DEPARTMENT OF THE AIR FORCE
HEADQUARTERS 377TH AIR BASE WING (AFMC)

SUBJECT: Addendum to Stage I Abatement Plan for ST-106, Bulk Fuels
Facility, Kirtland AFB

ADDENDUM 2 TO STAGE 1 ABATEMENT PLAN ST-106,

KIRTLAND AFB BULK FUELS FACILITY

Figure 1. Soil Boring Locations, KAFB Bulk Fuels Facility (ST-106)

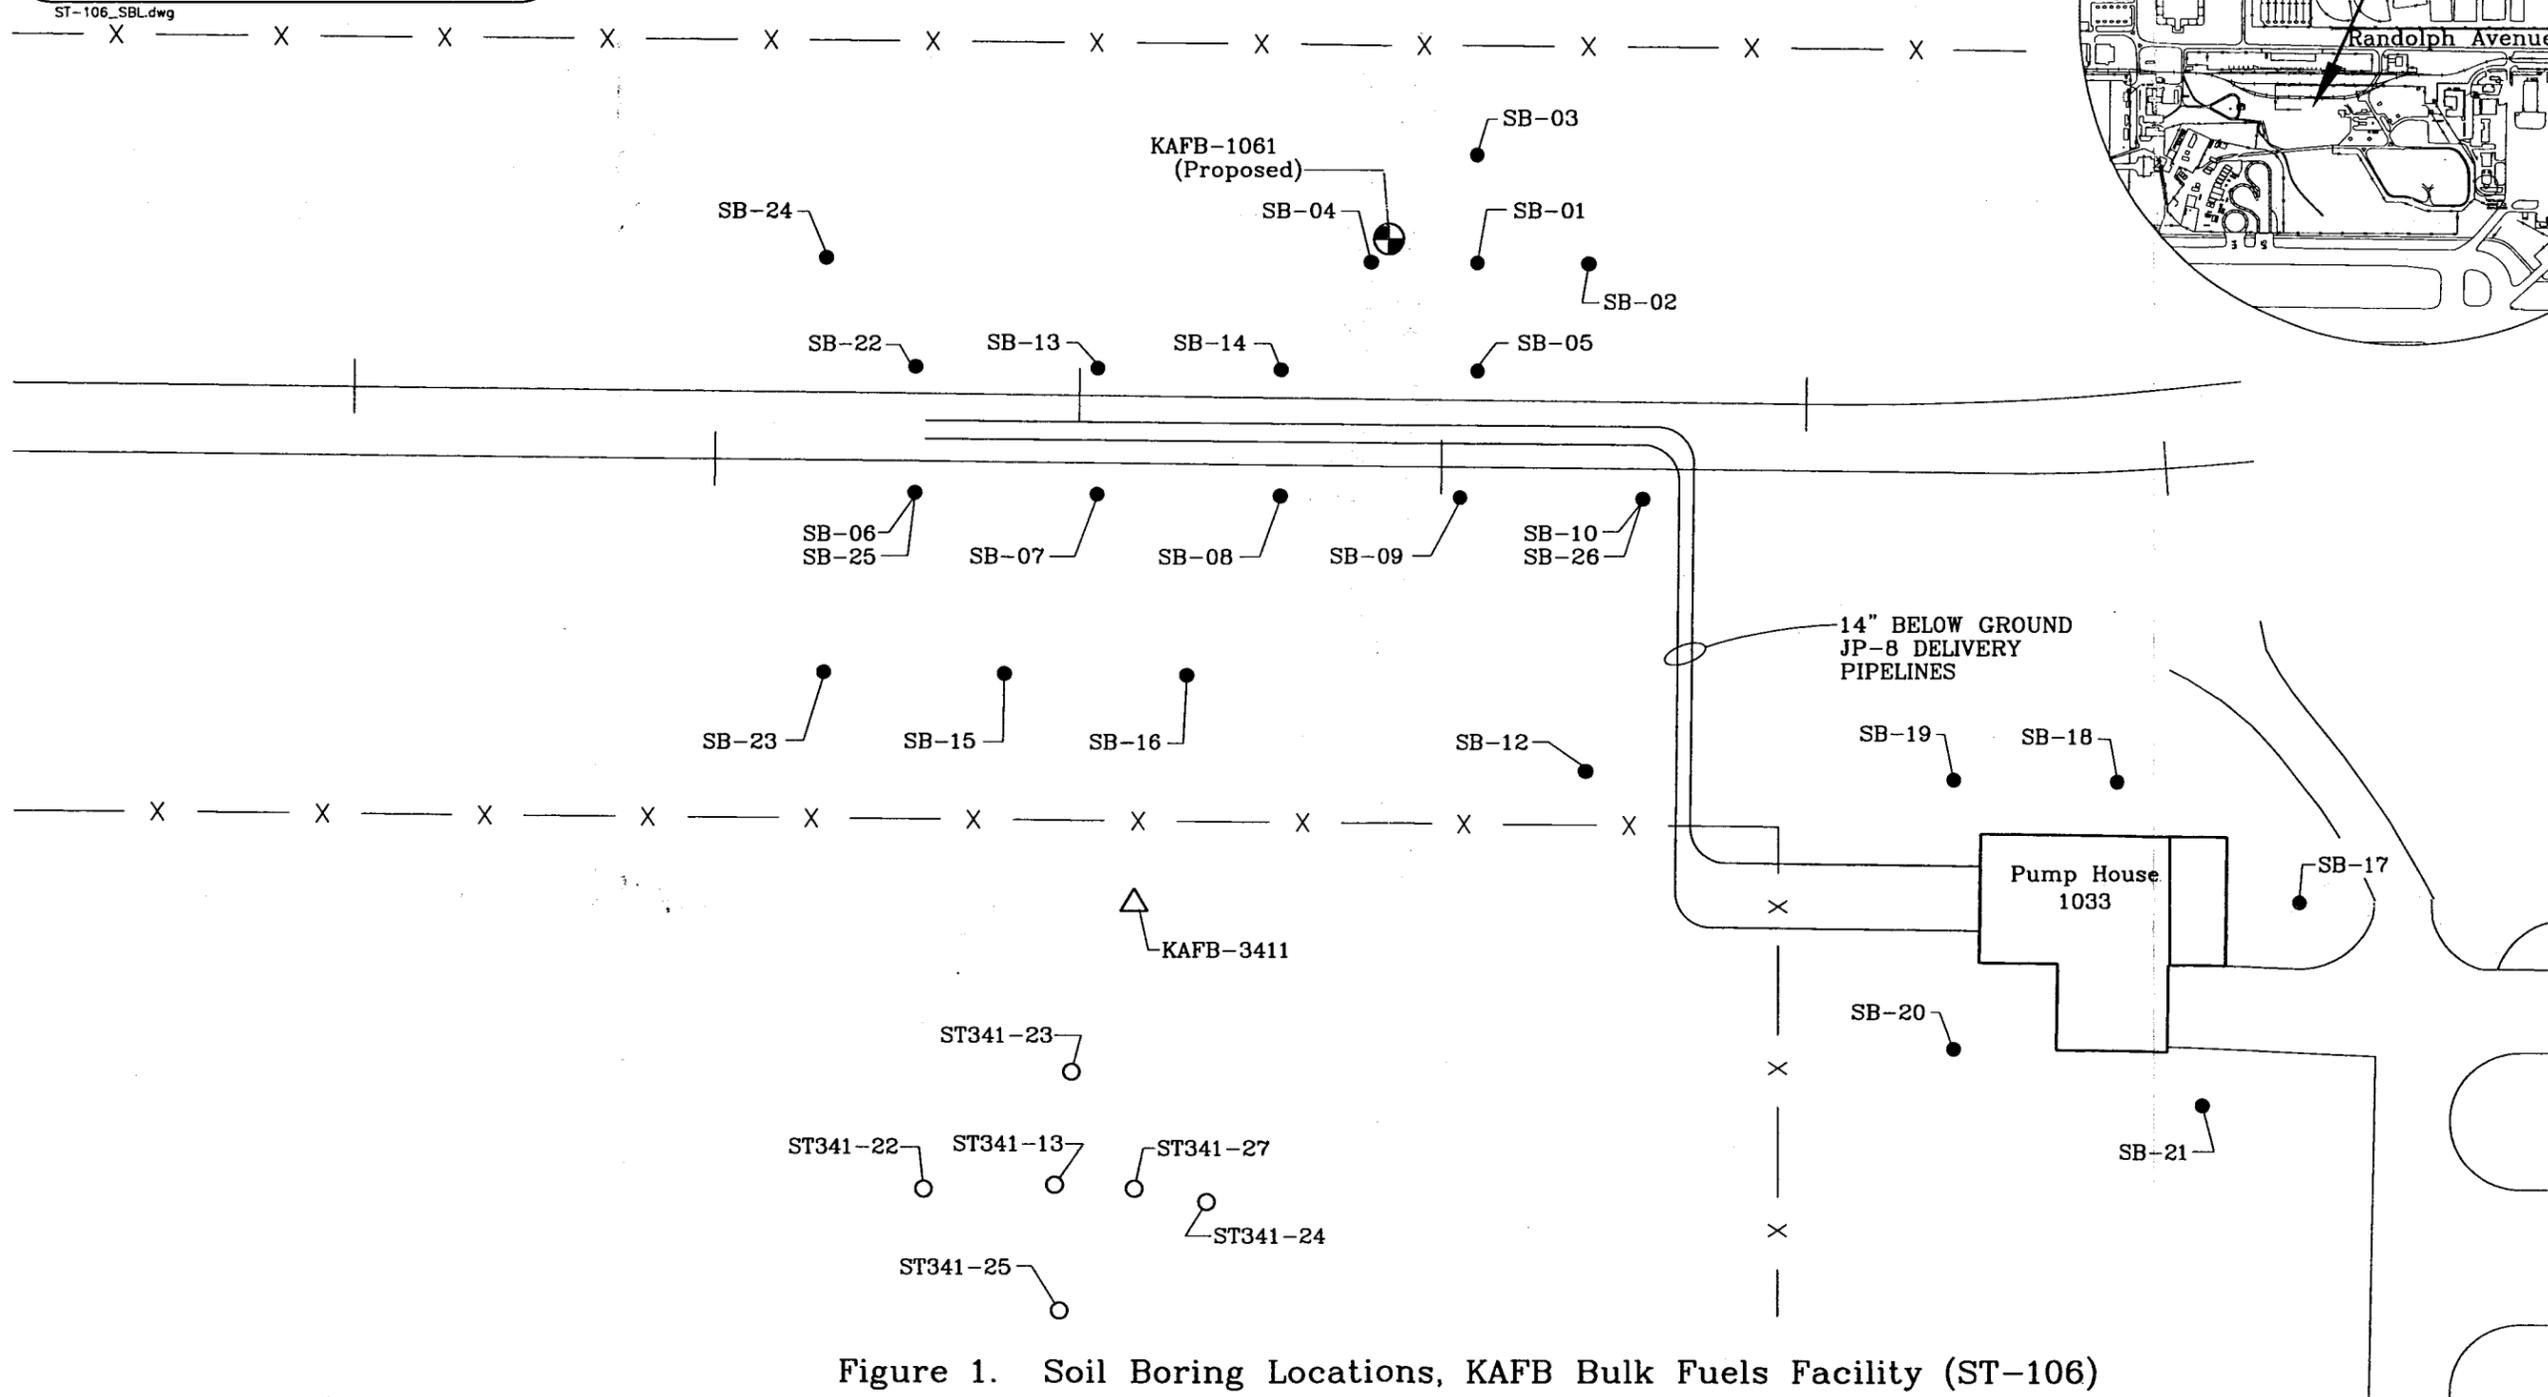
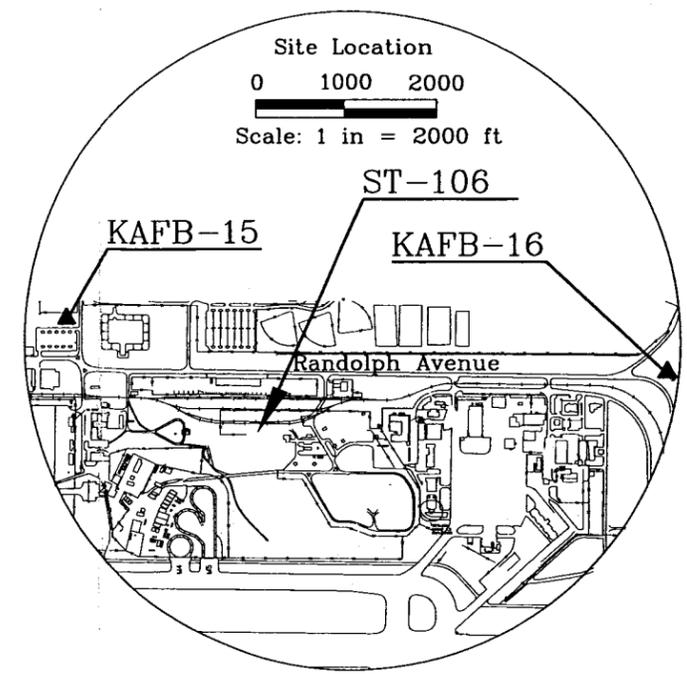
The installation of one groundwater monitoring well (KAFB-1061) is proposed to determine if the regional aquifer has been affected by the soil contamination (Figure 1). One round of ground water samples will be collected and analyzed for TPH, volatile organic compounds (VOCs), and semi-volatile organic compounds (SVOCs) (Table 1). Groundwater well installation and sampling will follow those procedures specified in the Base-Wide Plan SOP A1.6.

The initial groundwater well will be located north of the source (the 14" belowground pipeline) so that it is between the source and the water supply wells. The well will be located approximately 50 ft north of the pipeline, and approximately 75 ft west of the east end of the loading rack. The well installation and construction will conform to procedures specified in the Base-Wide Plan SOP A1.6. The well will be installed using air-rotary casing-hammer methods, have a 4 or 5-inch schedule 80 PVC casing, and 25 feet of 0.020 slot well-screen installed across the water table. During installation of the well, subsurface geology will be logged from drill cuttings and from soil samples. Soil samples will be collected every 10 feet from the surface to 100 ft bgs, every 20 feet from 100 feet bgs

The results of the soil samples from the well installation (KAFB-1061), the two previous deep borings (SB-25 and SB-26) and the data from the installation of well KAFB-3411 will be used to locate four additional soil borings to delineate the horizontal extent of the deep subsurface contamination (Figure 1). Soil sample collection will follow those procedures specified in the Base-Wide Plan SOP A1.6. Sample information is summarized below:

- Four boreholes will be advanced in the JP8 off-loading rack area. Borings will be located northwest and southwest of SB-25, and northeast and southeast of the SB-26. The borings will be advanced to the depth of approximately 300 ft bgs. The goal of these initial four borings is to identify the horizontal extent of the TPH contamination. Therefore all attempts will be made using the available data to locate the borings far enough from the loading rack so that none of the soil results exceed the NMED TPH guideline of 100 ppm or any of the US EPA Region 6 risk-based human health soil screening criteria for VOCs and SVOCs while not being too far away from the loading rack to adequately constrain the horizontal extent of contamination.
